PARTS & SERVICE NEWS

REF NO.	AT00197A
DATE	Dec. 22, 2000
(C)	Page 1 of 12

SUBJECT: INTRODUCTION OF LOW OPERATOR COMPARTMENT NOISE SPEC. HD465/605-5

APPLICATION: HD465-5 Dump Trucks, Serial Nos. 4001 and up
HD605-5 Dump Trucks, Serial Nos. 1001 and up

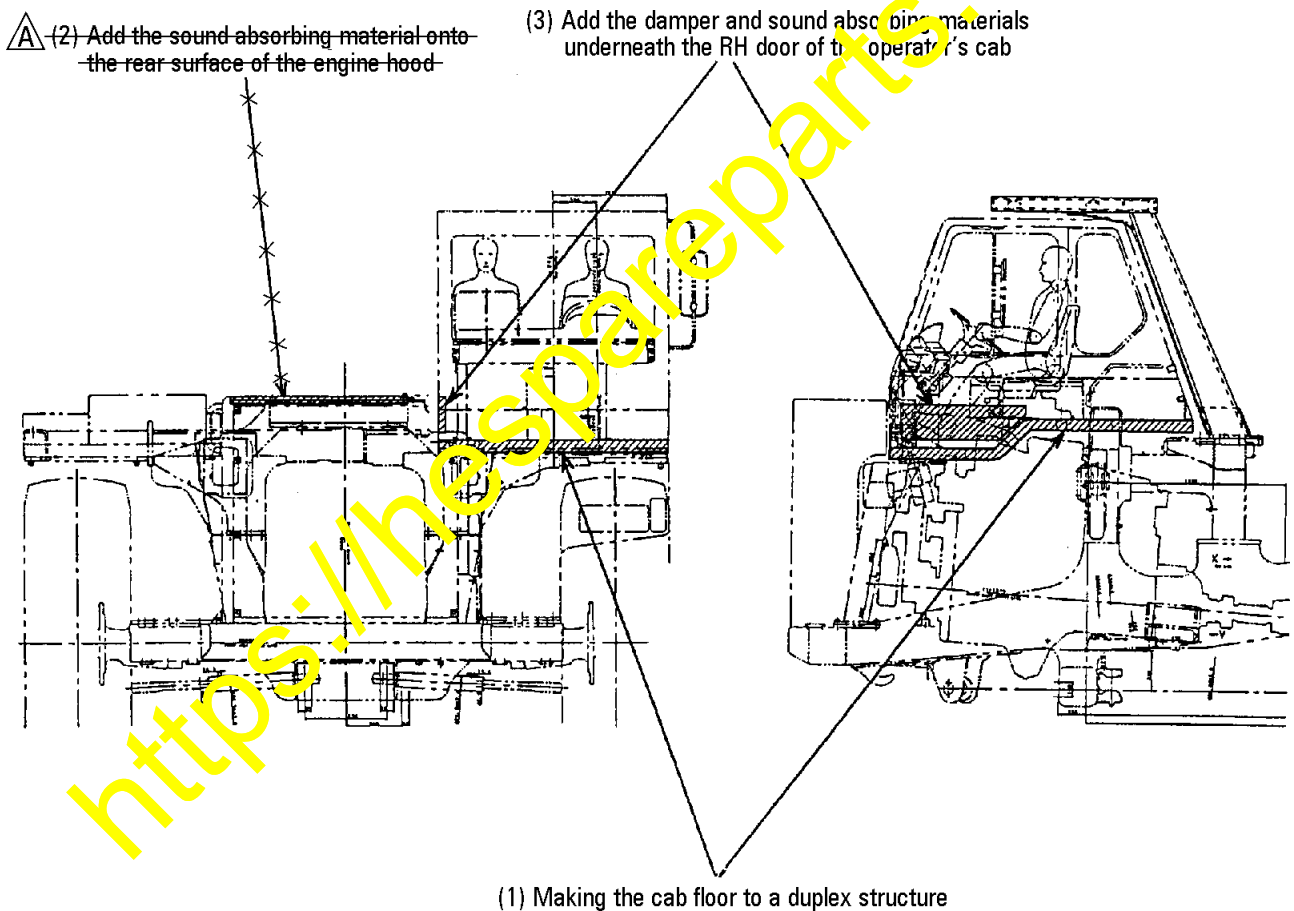
To suppress the noise level inside the operator's compartment, supplement the following structures and parts to improve the noise insulation factor against noise coming from external sources.

(1) Making the cab floor to a duplex structure

Making the cab floor to a duplex structure, insert damping materials (dampers) and sound absorbing materials (sheets) in between.

(3) Add the dampers and sound absorbing materials underneath the RH door of the operator's cab

Since this section is in hollow state currently, install the dampers and sound absorbing materials into this space.

Fig. 4

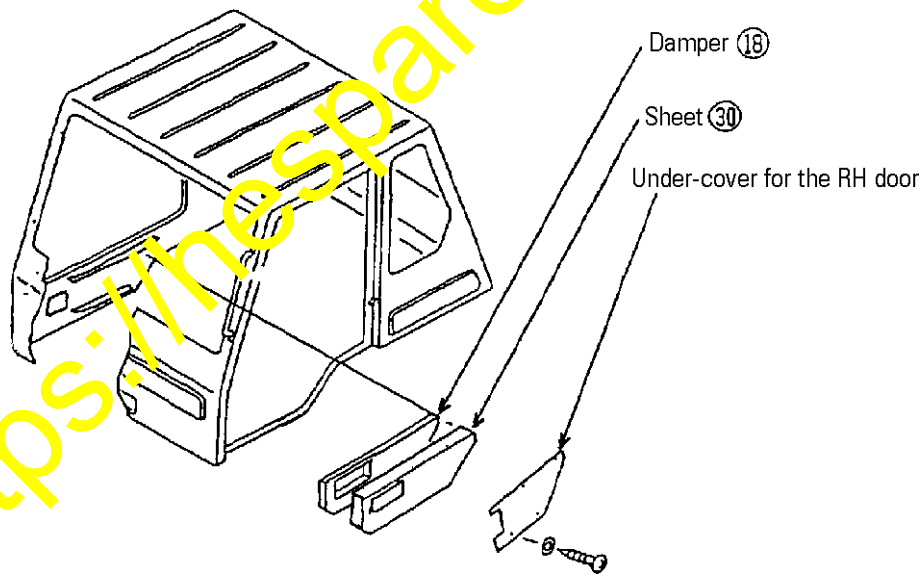
Apply the damper  (569-89-65320) to the surface of the section from where the under-cover (561-54-62382) for the RH door has been removed. Since adhesive is applied to one side of the damper, remove the protection sheet before applying the damper. At this time, depress the damper onto the operator's cab panel using a hammer or the sort.

Apply the sheet  (569-89-65530) onto the surface of the damper . Since adhesive is applied to one side of this sheet, remove the protection sheet before applying the sheet onto the damper surface.

If it is difficult to apply the aforementioned damper  and sheet  in whole being hindered by existence of air conditioner hoses or other structures, they may also be split to appropriate shapes.

Fig. 5 Reworking drawing for the operator's cab floor:
A bottom view, viewed from underneath the operator's cab floor.

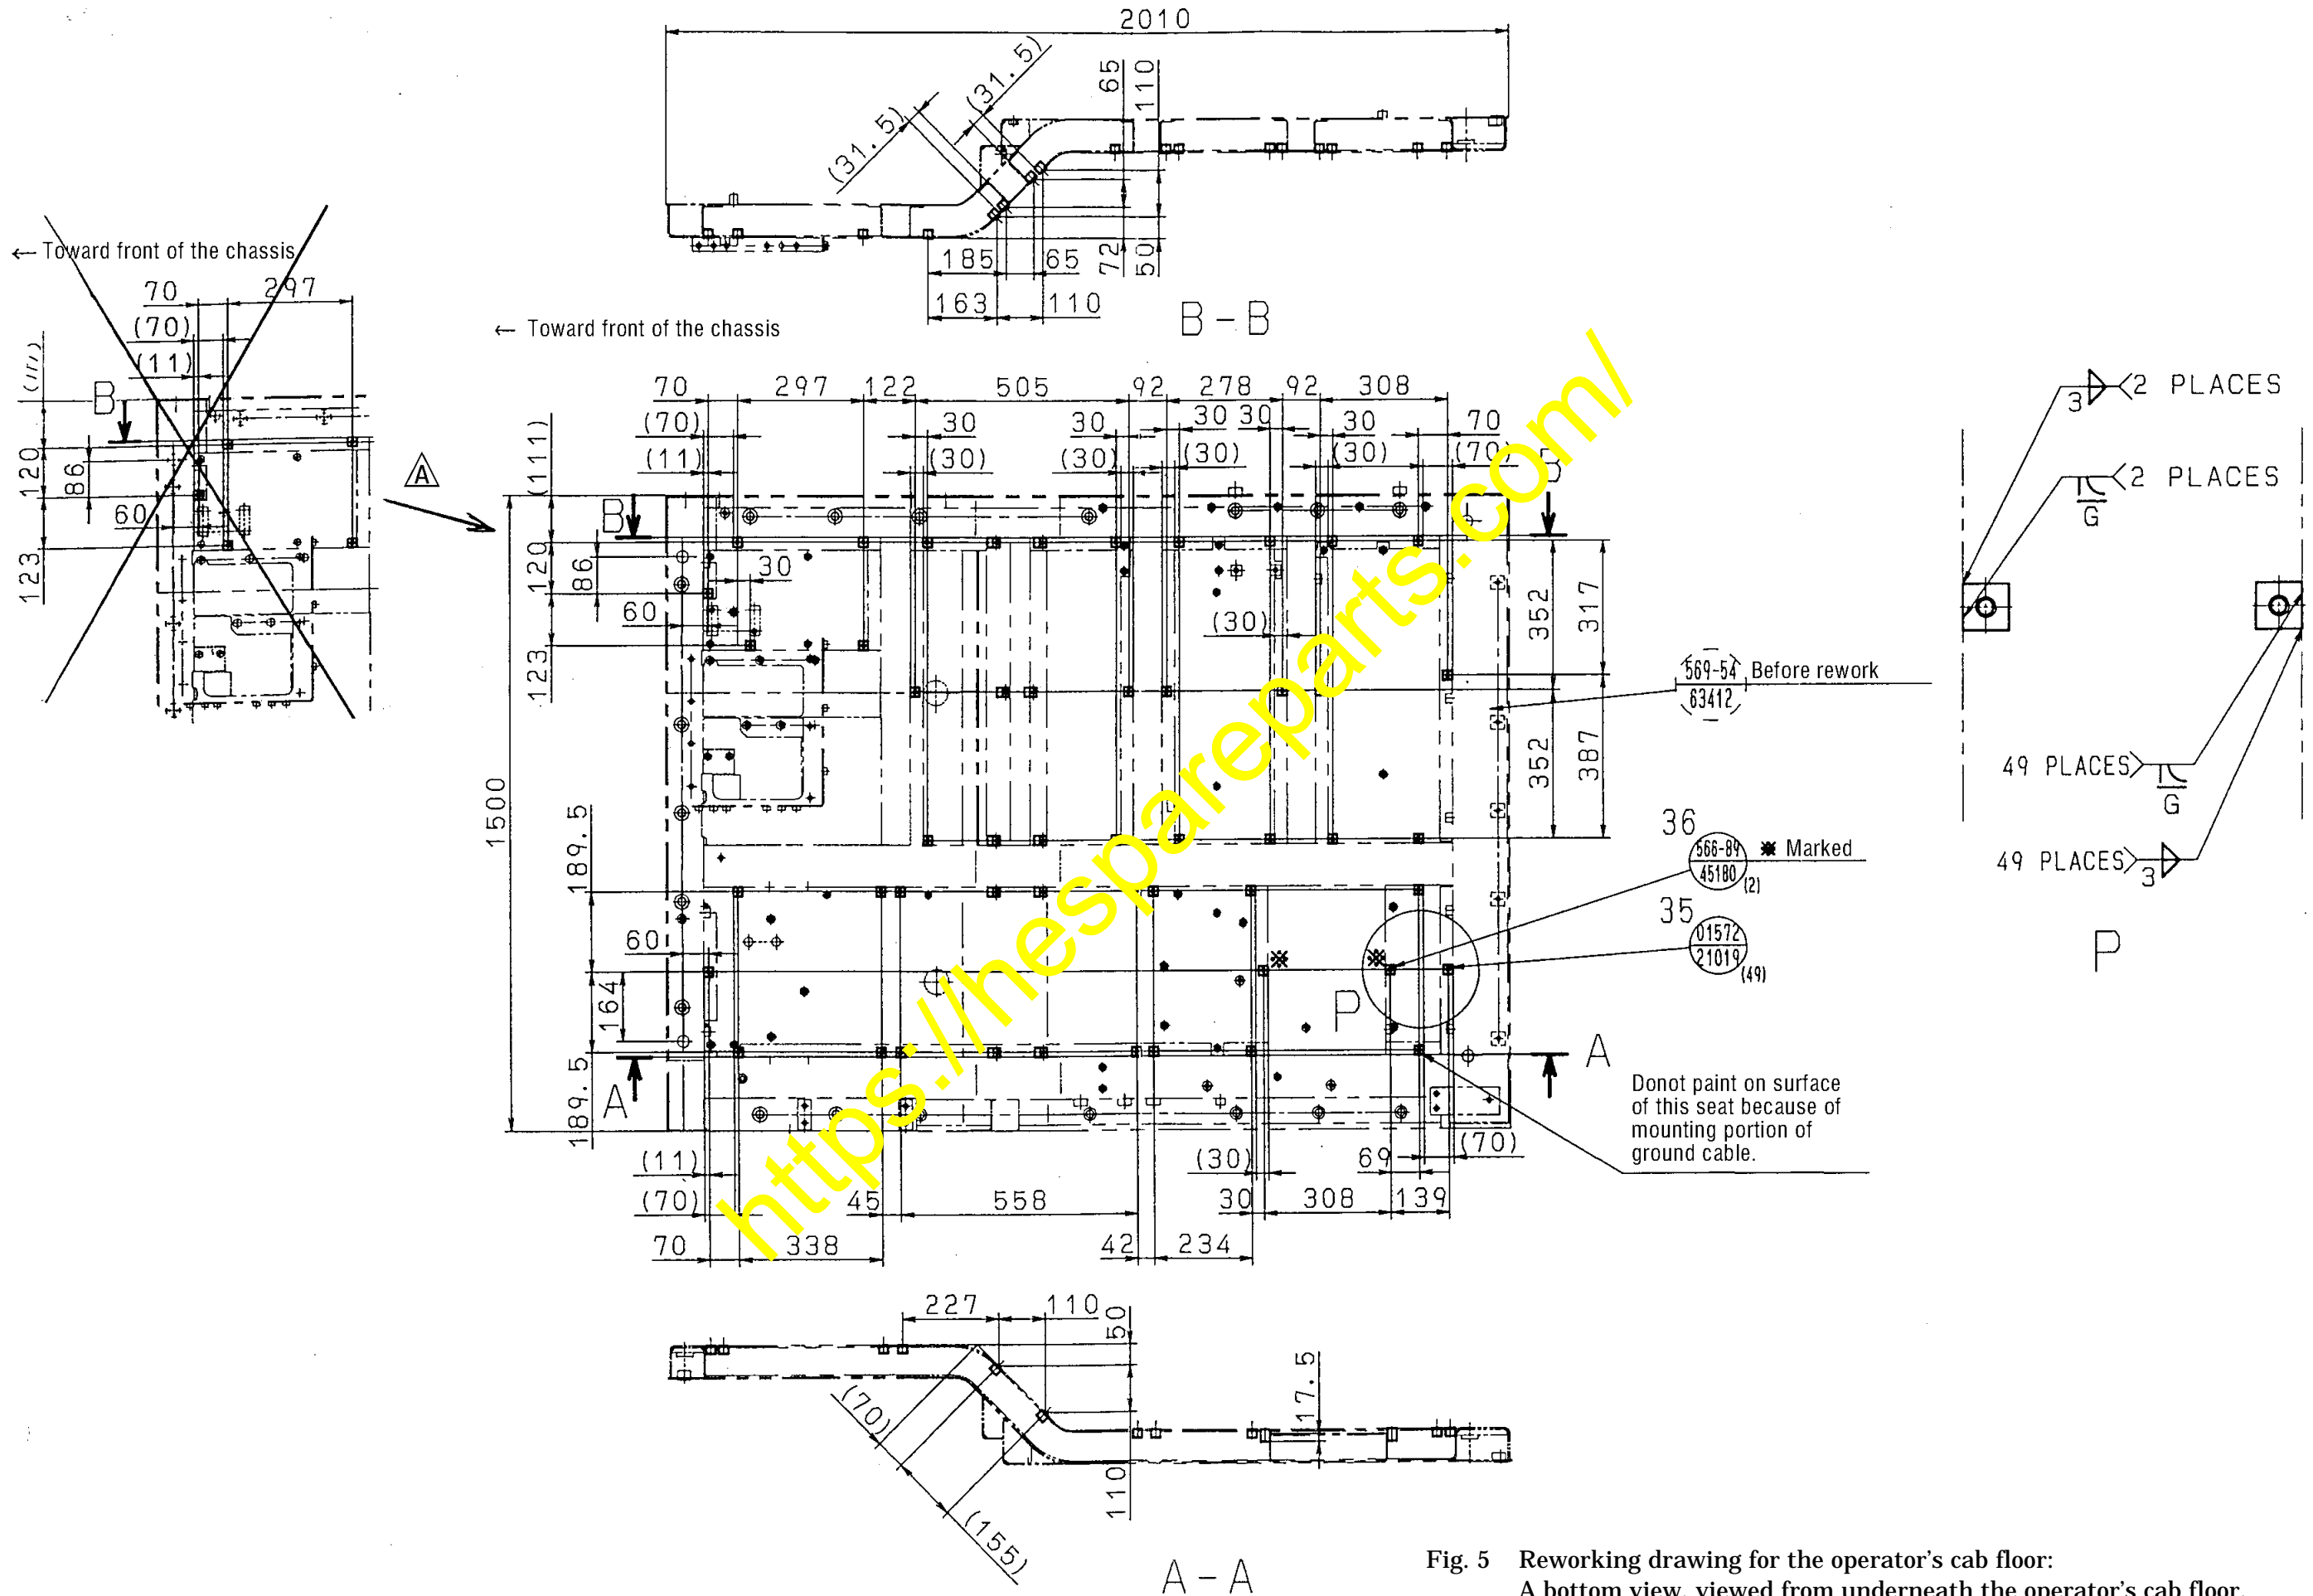
Weld the seat ③⑤ (01572-21019) and the seat ③⑥ (566-89-45180) onto the bottom surface of the operator's cab floor.

Fig. 6 Drawing for installation of the dampers (a bottom view)

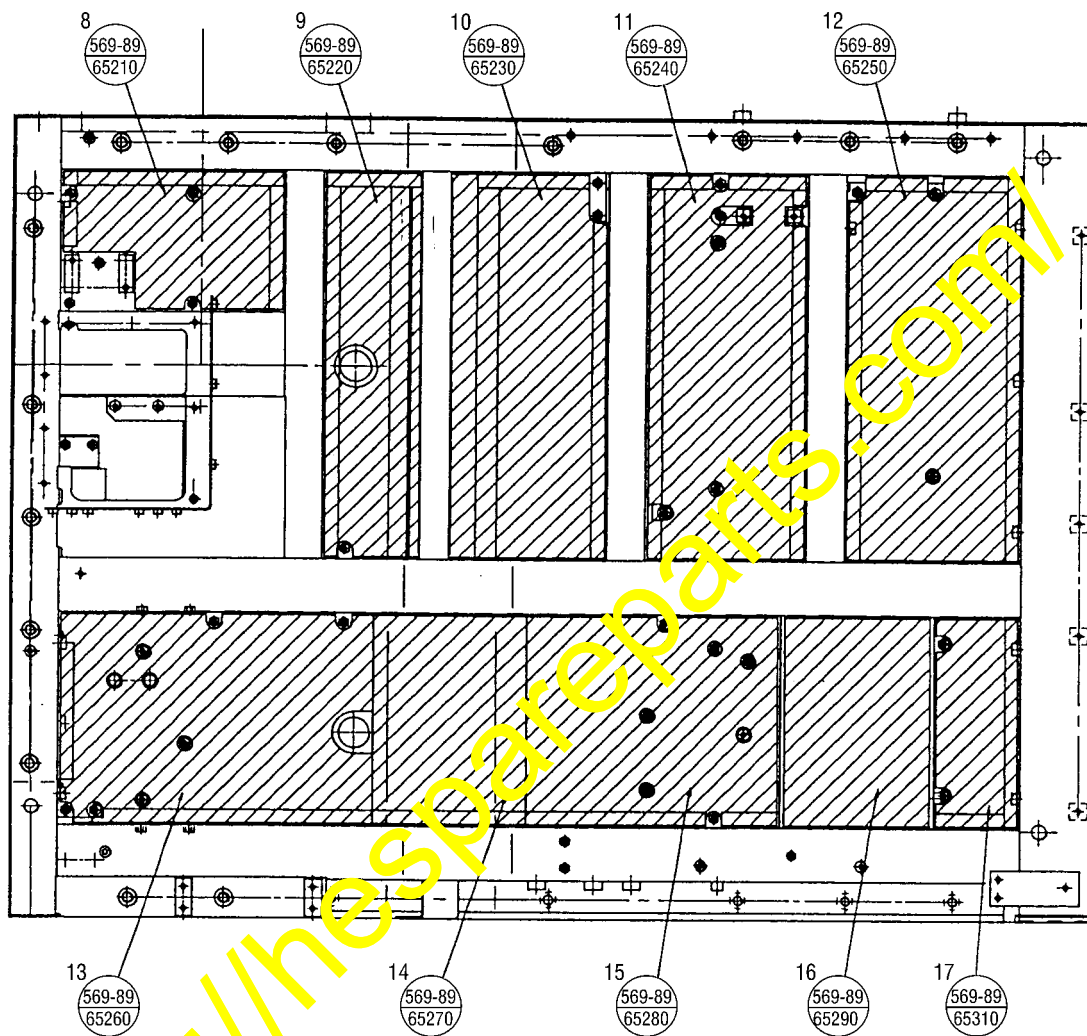
Apply the dampers ⑧ thru ⑰ onto the bottom surface of the operator's cab floor. Since adhesive is applied to one side of the dampers, remove the protection sheet before applying the dampers. At this time, depress the dampers onto the bottom surface of the operator's cab floor using a hammer.

Fig. 7 Drawing for installation of the sheets (a bottom view)

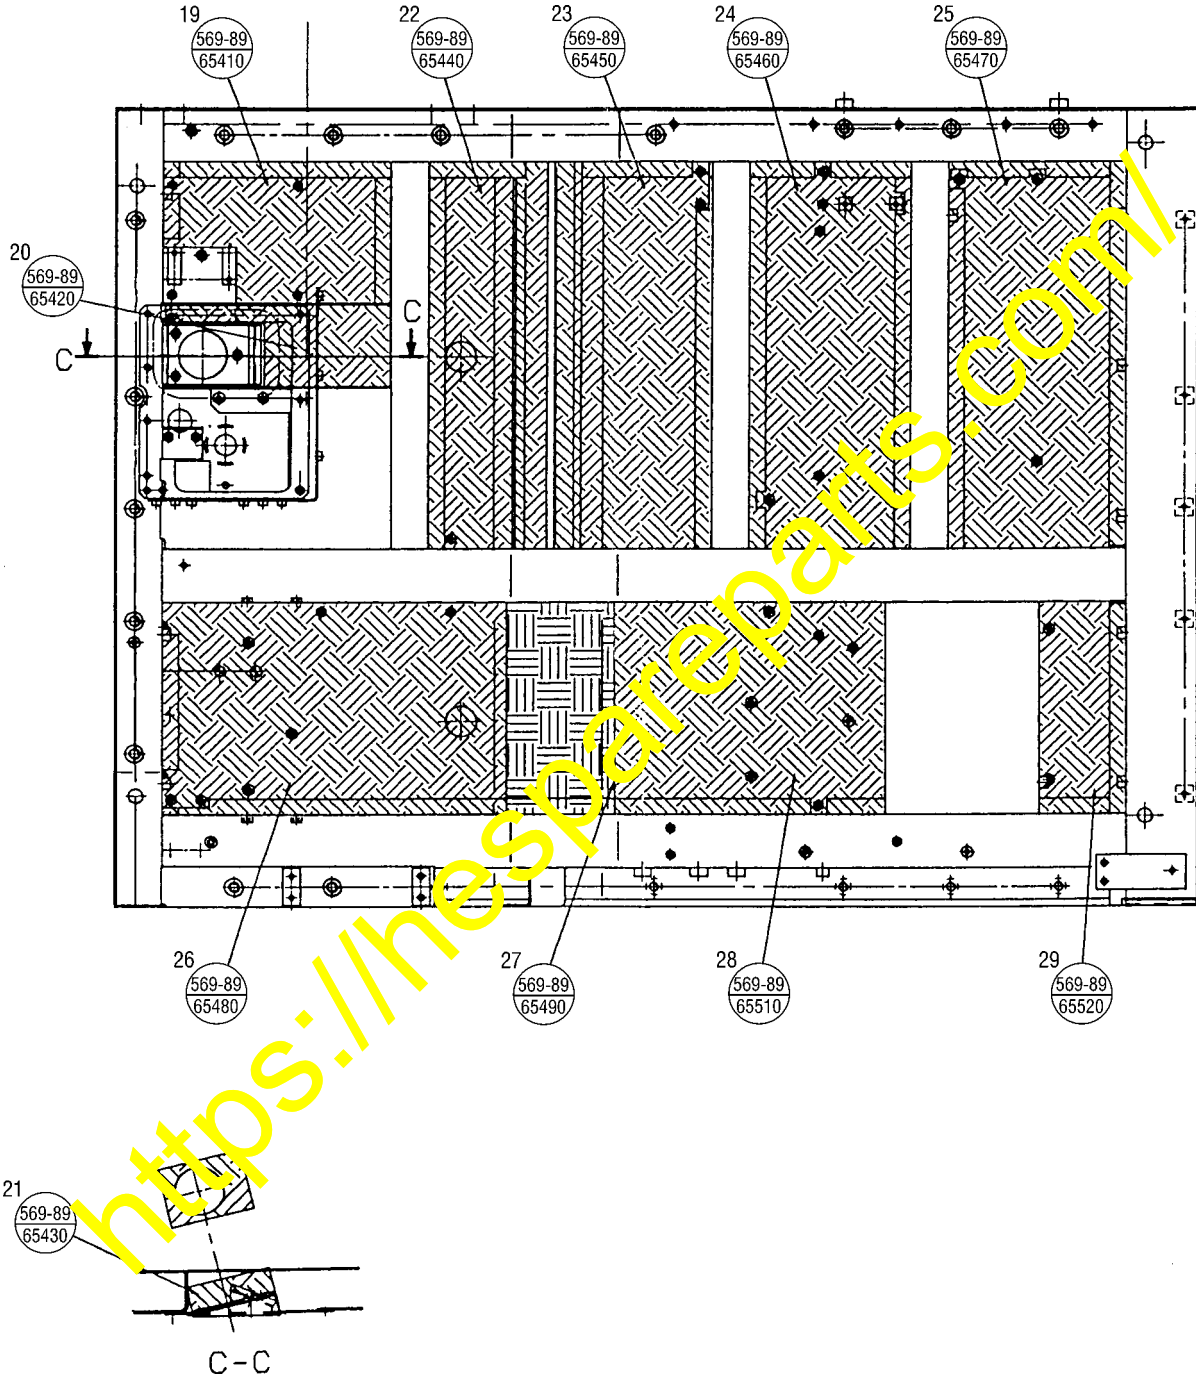
Apply the sheets ⑱ and ⑳ thru ㉑ onto the surface of the dampers which have been applied onto the bottom surface of the operator's cab floor according to the procedure in the above Paragraph 1).
